DS-K1T342 Series MinMoe Release Notes
(2026-2-4)

| Device Model:

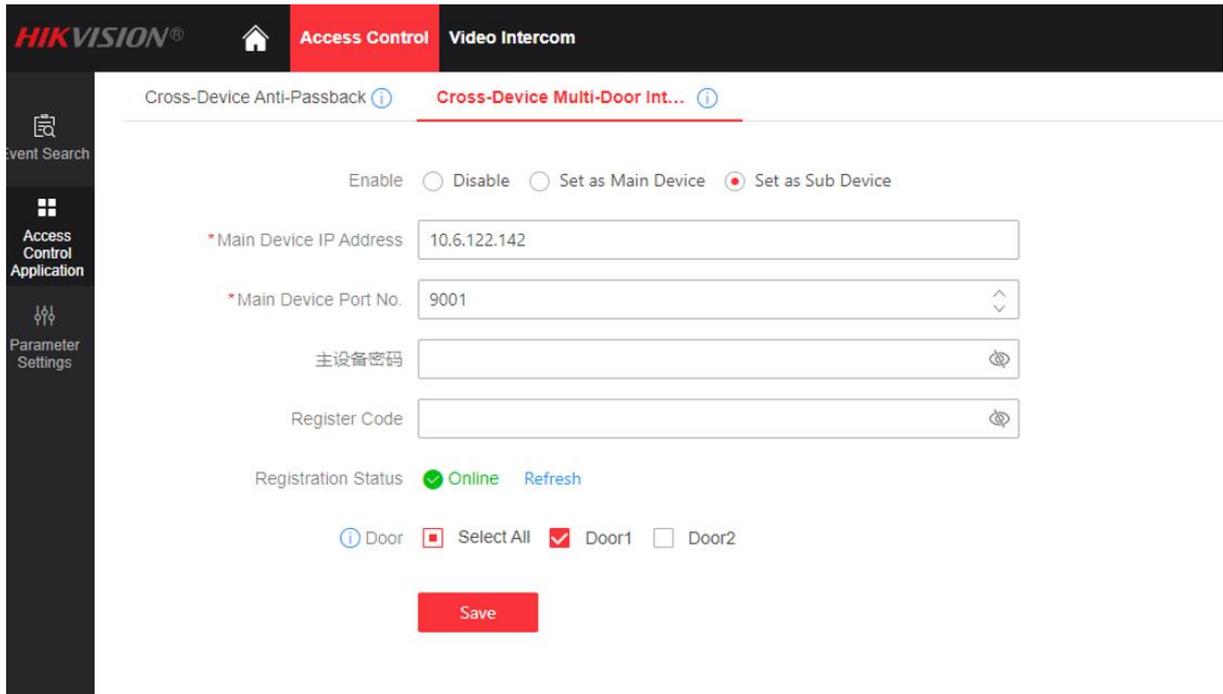
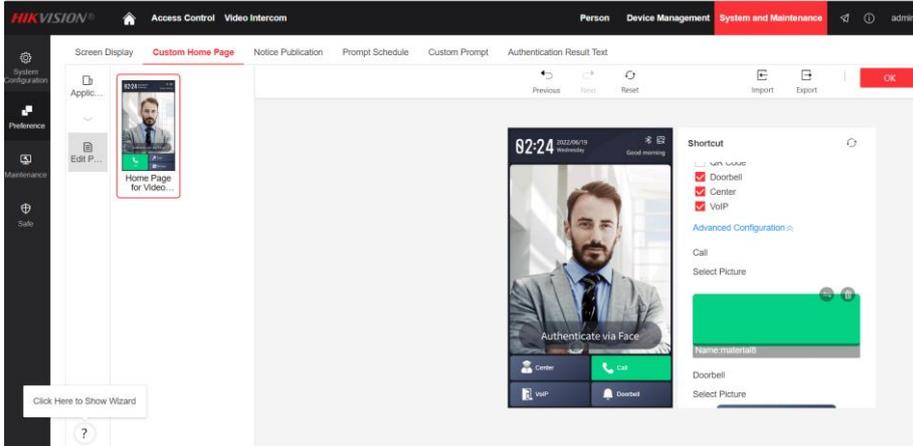
13. The main screen supports one-click call to the VoIP center
14. Support Hik-Connect Team Cloud Intercom
15. Support intercom mode configuration

**Remark**: The main screen can be configured with call modes, and the function buttons can be customized.

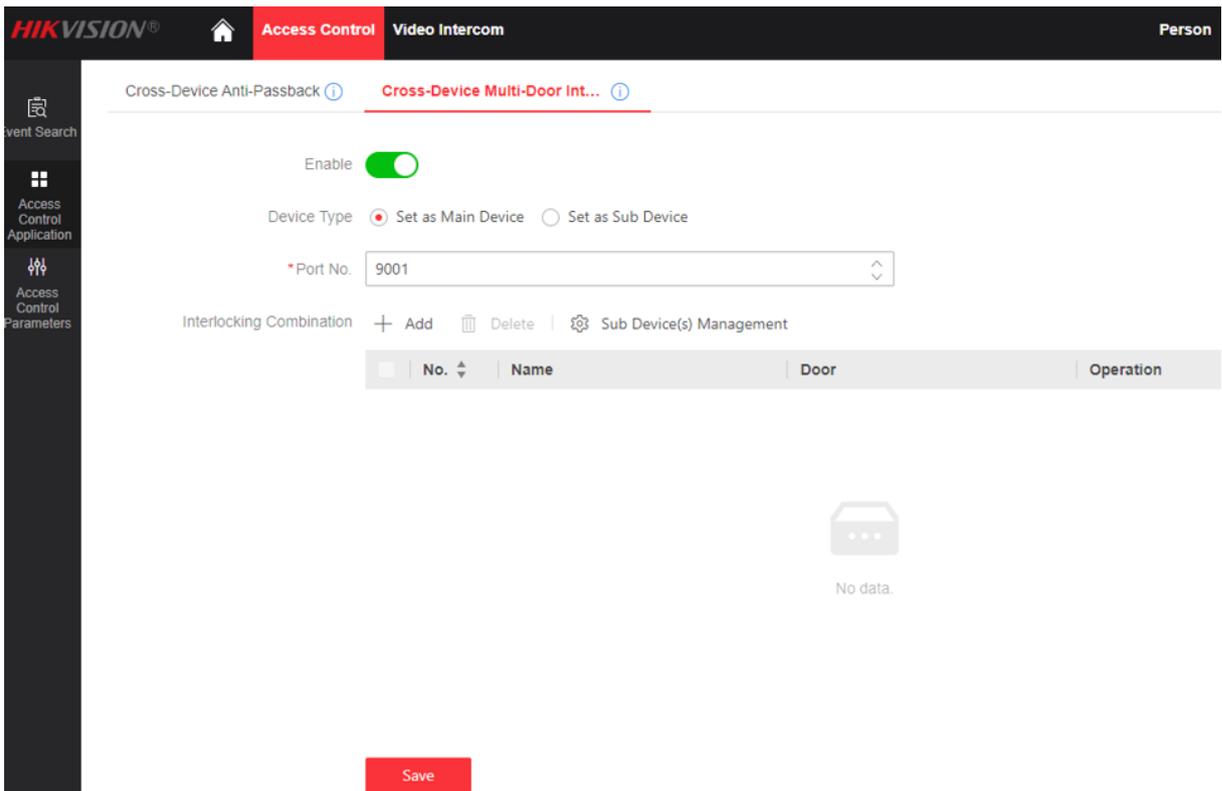
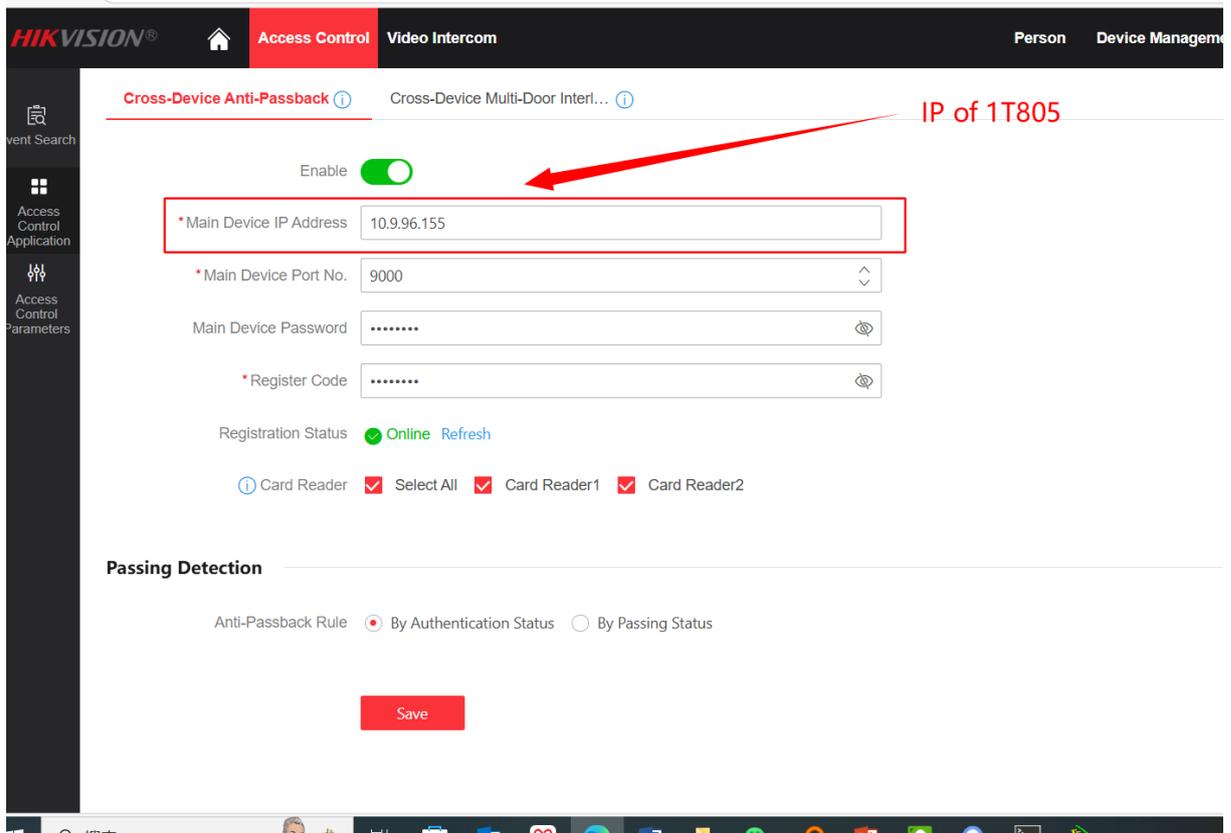
- **Access control**
1. Support multi-door interlock between devices

Remark: Users can configure the doors of different devices as interlock groups, and if one of the doors in the interlock group is open, the other doors cannot be opened.

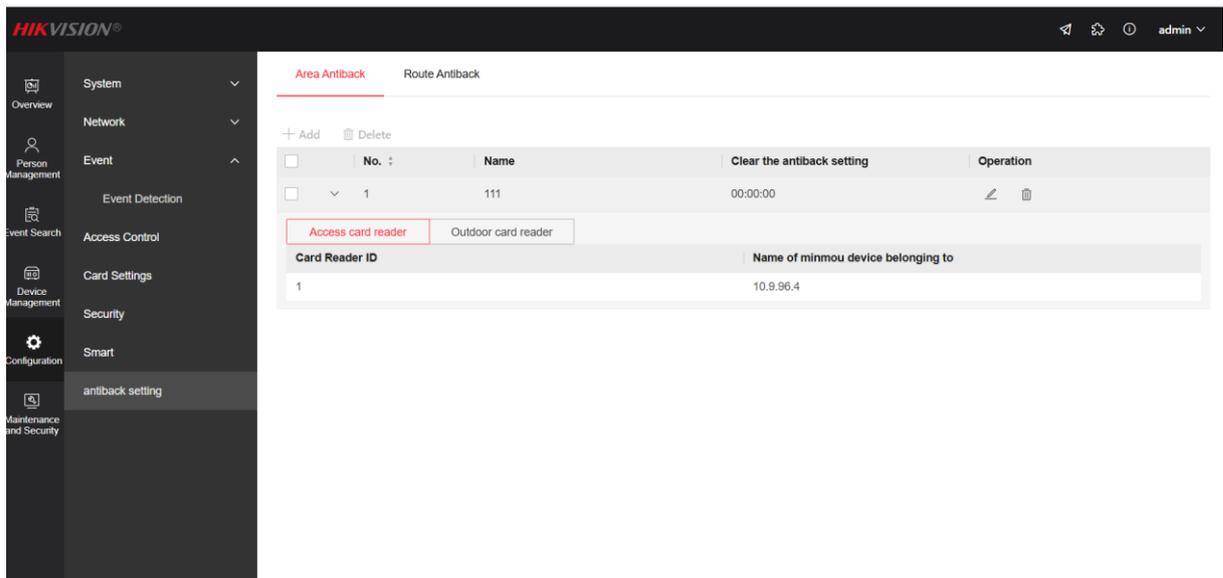
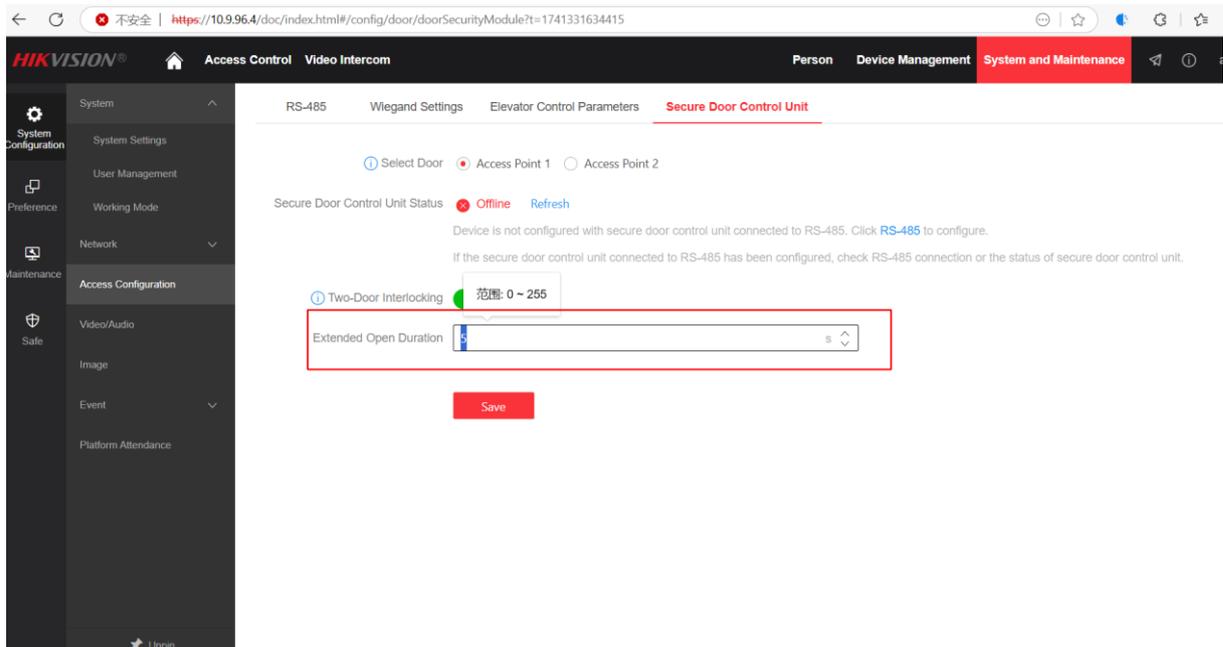
2. Support multi-door interlock delay for door opening in the device

Remark: form 0 to 255 seconds.

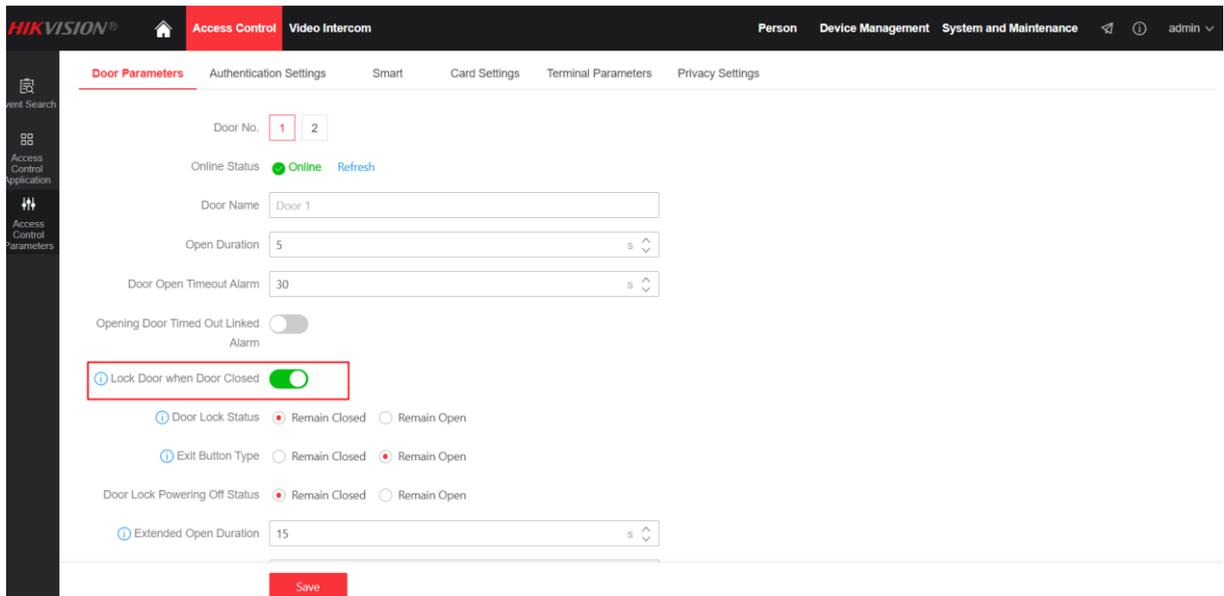
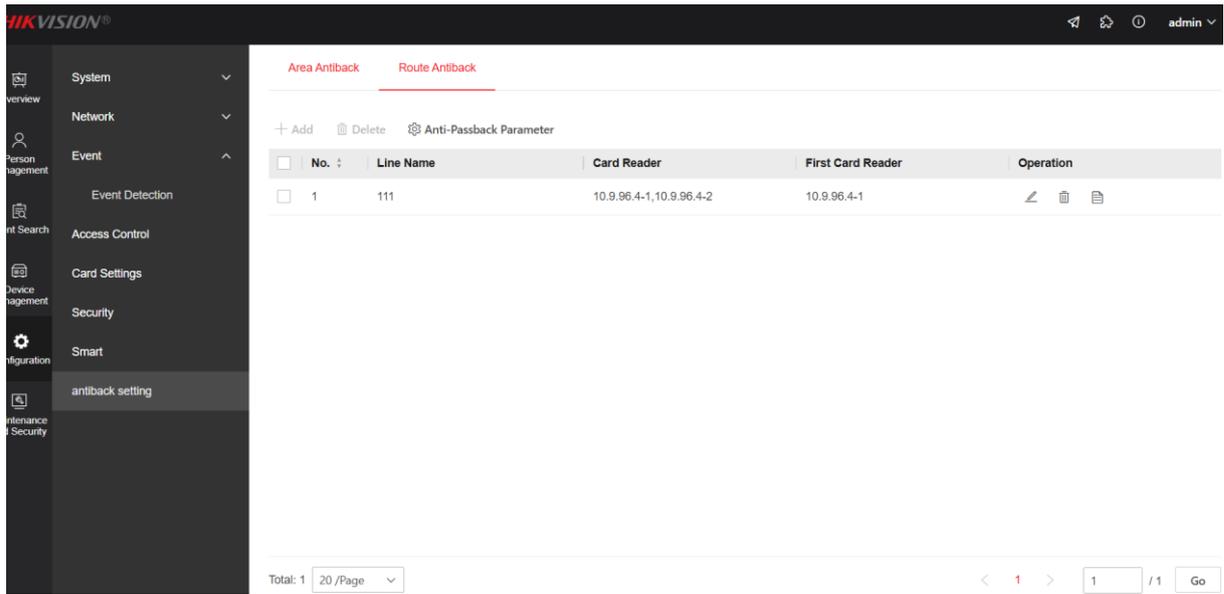
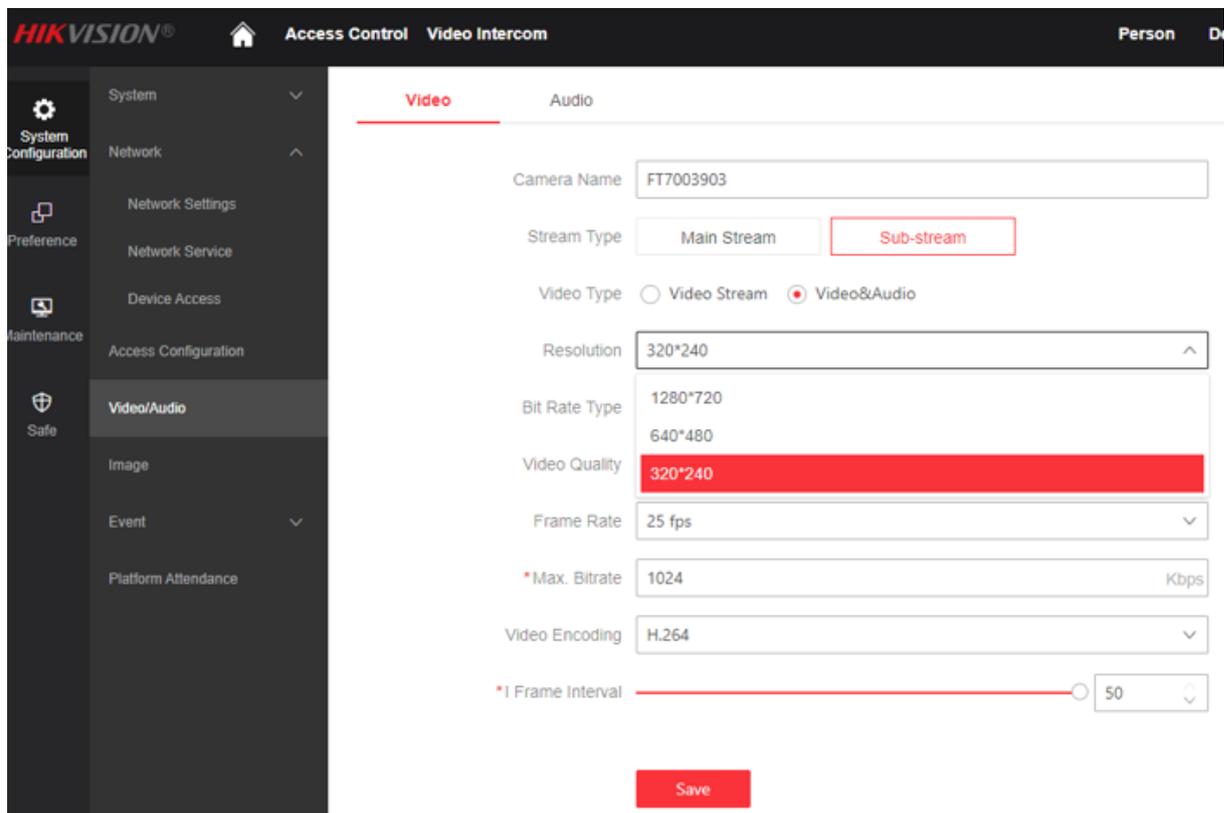
3. Support cross-device anti-passback as a slave device configuration

Remark: It is paired with a customized version firmware of DS-K1T805FW(V1.8.1 build) who is used as anti-passback server.

Area Antiback: The entry and exit of people in the area must be matched, otherwise it will not be passable.

Route Antiback: Personnel must be certified in turn according to the set route, and the passage is only one way.

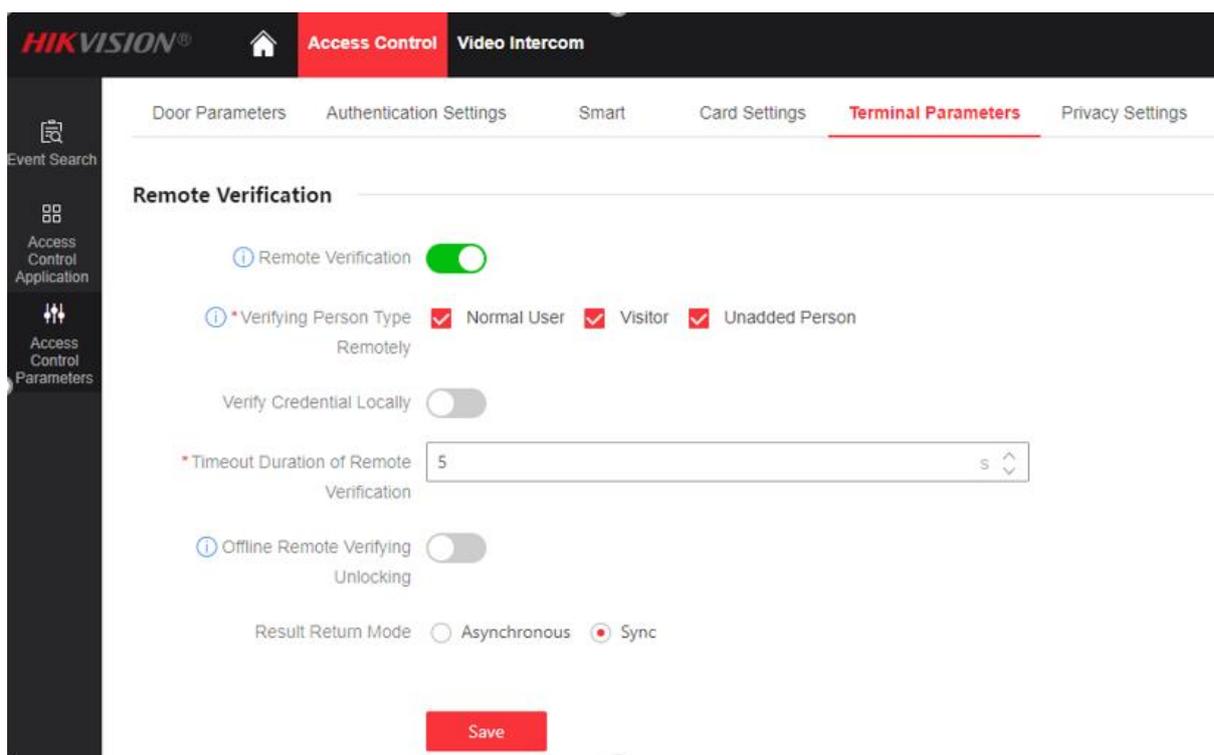
4. Support remote verification based on different person type

Remark: You can choose different person type to join the remote verification.The 342 support platform anti-pass back with HikCentral platform by using this configuration.

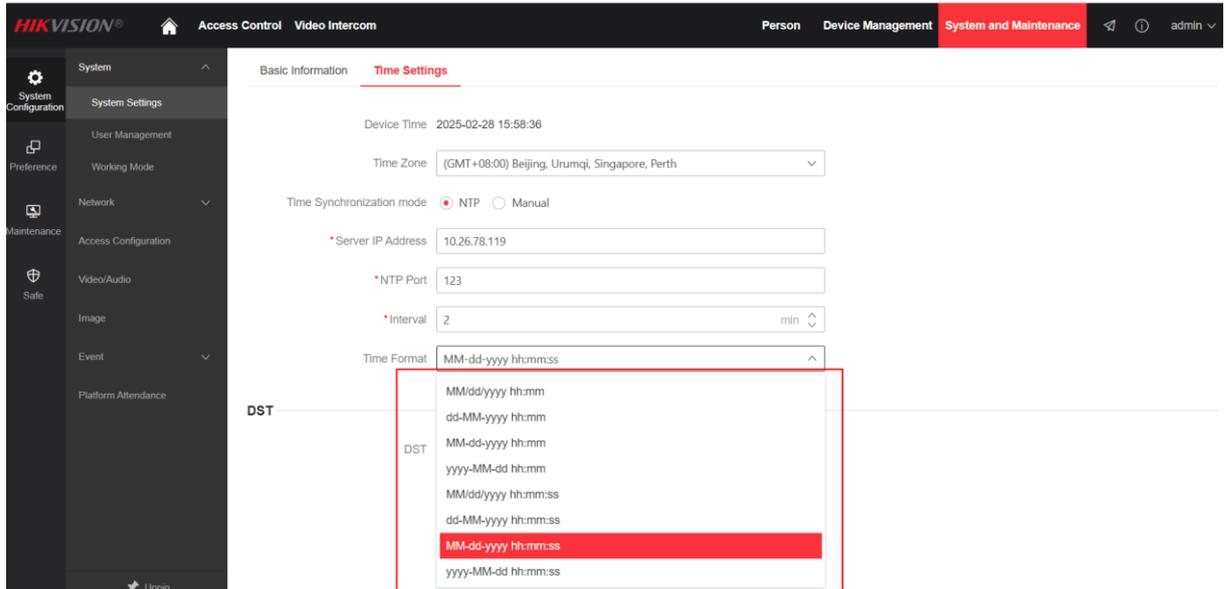
6. Support operator user type in personnel information: Administrator, Operator, Basic Person

<u>Remark</u>: Administrator can edit all configurations of the device. Operator just can edit person. Basic Person can't edit any configuration of the device.

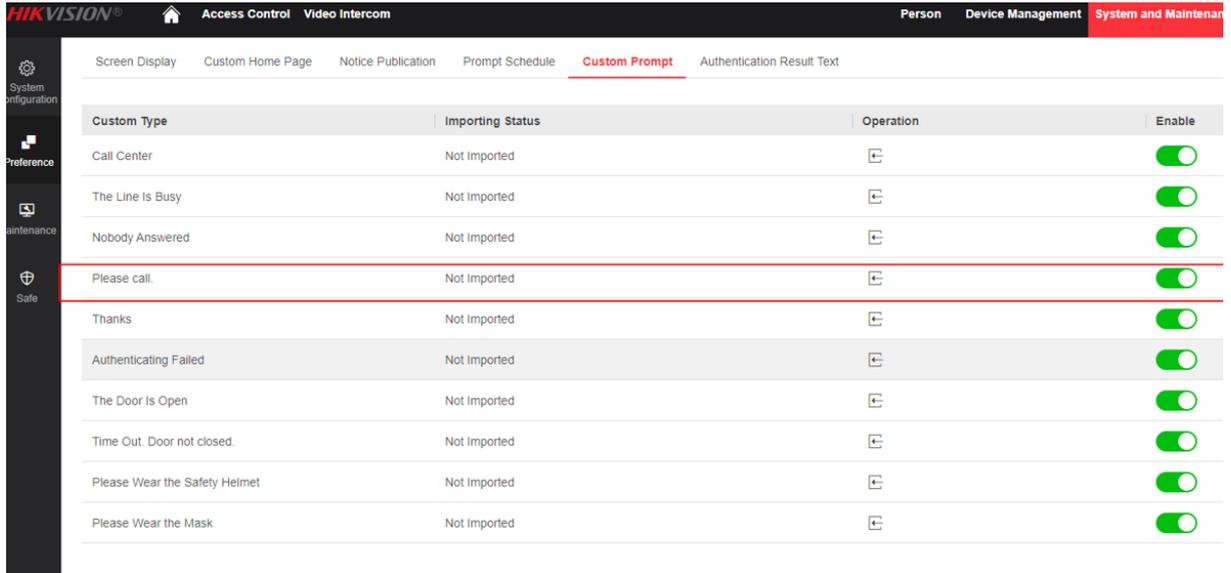
9. Support uploading door magnetic events to Hik-Connect
10. Support enabling and disabling custom prompt sounds

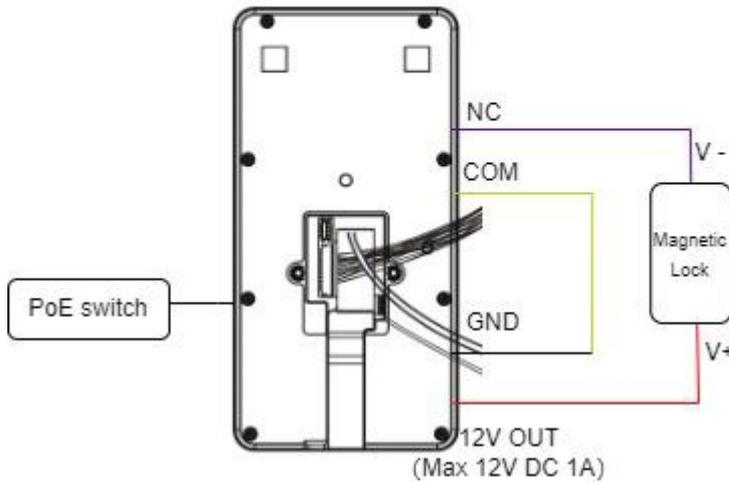
5. Configuration via the web client and enroll face picture with mobile phone camera.
6. Face Recognition Distance: 0.3 m to 1.5 m; Duration ＜ 0.2 s/User; Accuracy rate ≥ 99%
7. IP65 protection level
8. Power supply by standard PoE(af) and at the same time powers supply for door lock (max 12 VDC/1 A)

Note：*Only when device is powered by PoE, it will have power output for the lock, if the device is powered with 12V DC adapter, please power the lock with power adapter.*

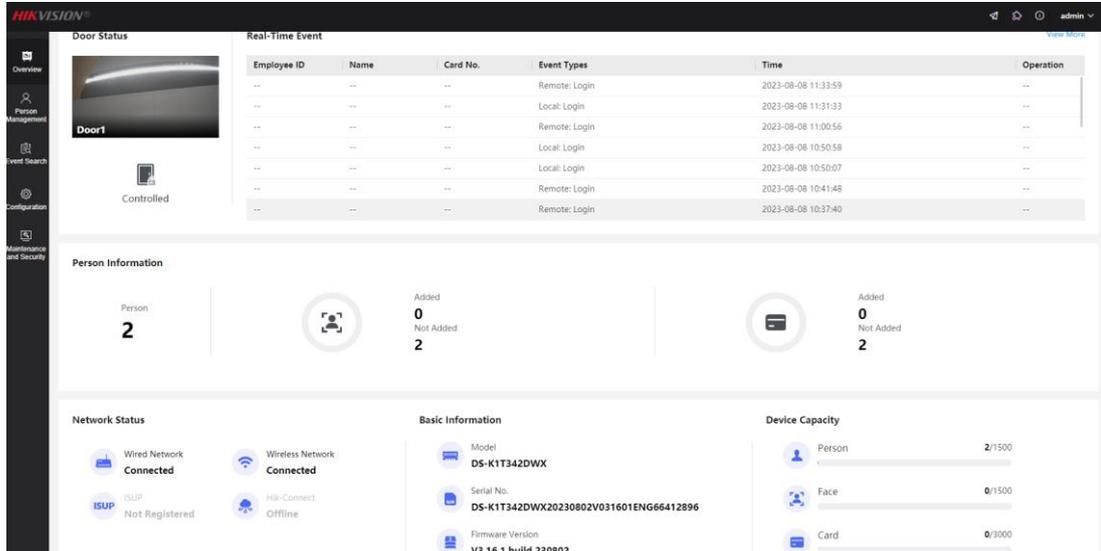
1. User friendly web design
